Permit No. 01283 Issued 11-24-86
date

Additional Information: Two story addition connecting the existing house and garage making the present garage attached.

PLAN REVIEW COMMENTS
FOR

A PROPOSED 2-STORY ADDITION
TO THE RESIDENCE LOCATED
AT 1036 WOODLAWN-NAPOLEON, OHIO
OWNED BY GARY GESSNER
11-24-86

LUMBERMATE COMPANY
SAINT LOUIS, MISSOURI

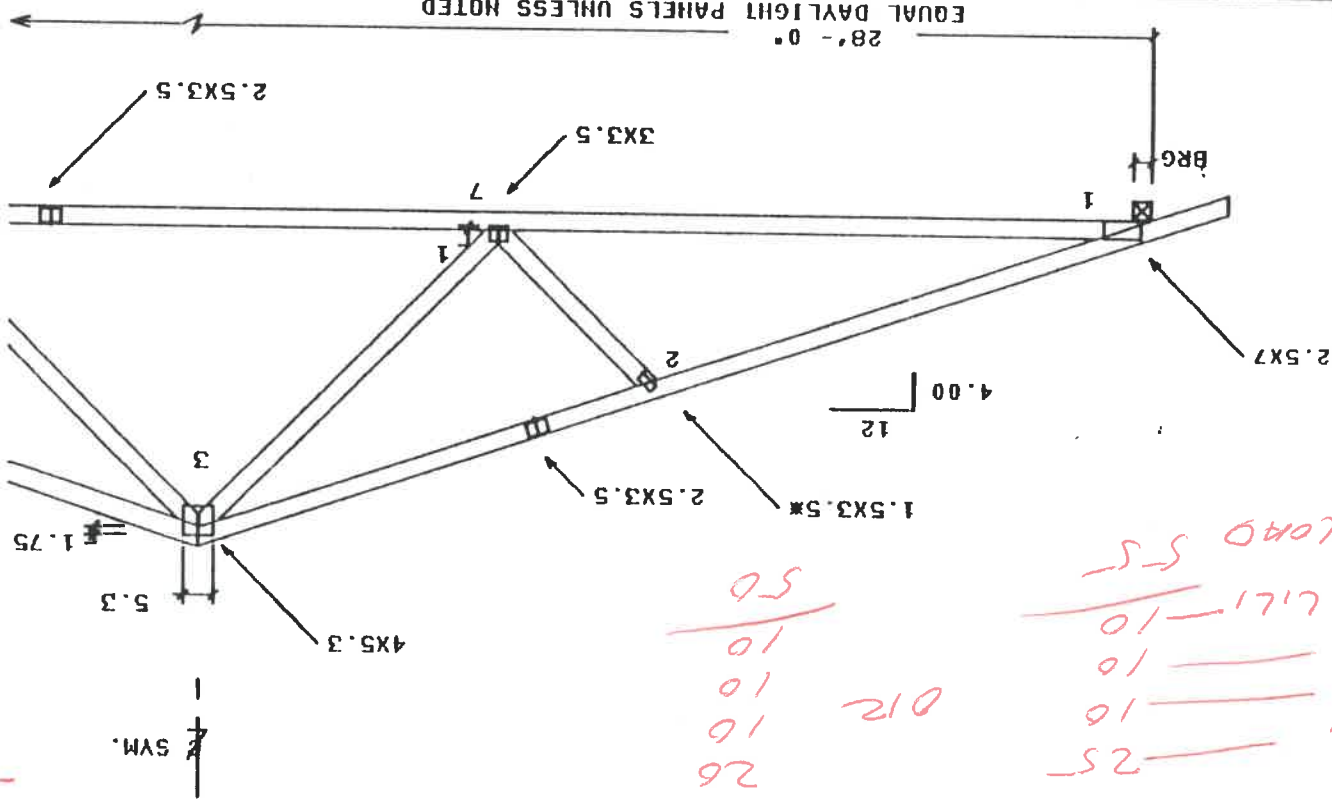
Not Approved
12-4-86
FH

*ADD 10 #P.S.F.
BOT CHORD LIVE LOAD*

*To L.L. --- 25
To D.C. --- 10
Bot CORD L.L. --- 10
To Top C. L. --- 10
Total CORD L.L. --- 55*

EXCUSED FWO YEAR TRUSS DIAGRAM
WHICH I HAVE REJECTED
DOR TO THE LACK OF A
10 # P.S.F. BOT. CORD ~~ELIVE~~ LOAD

RESUBMIT A CORRECTED DIAGRAM
BEFOR INSTALING TRUSSES
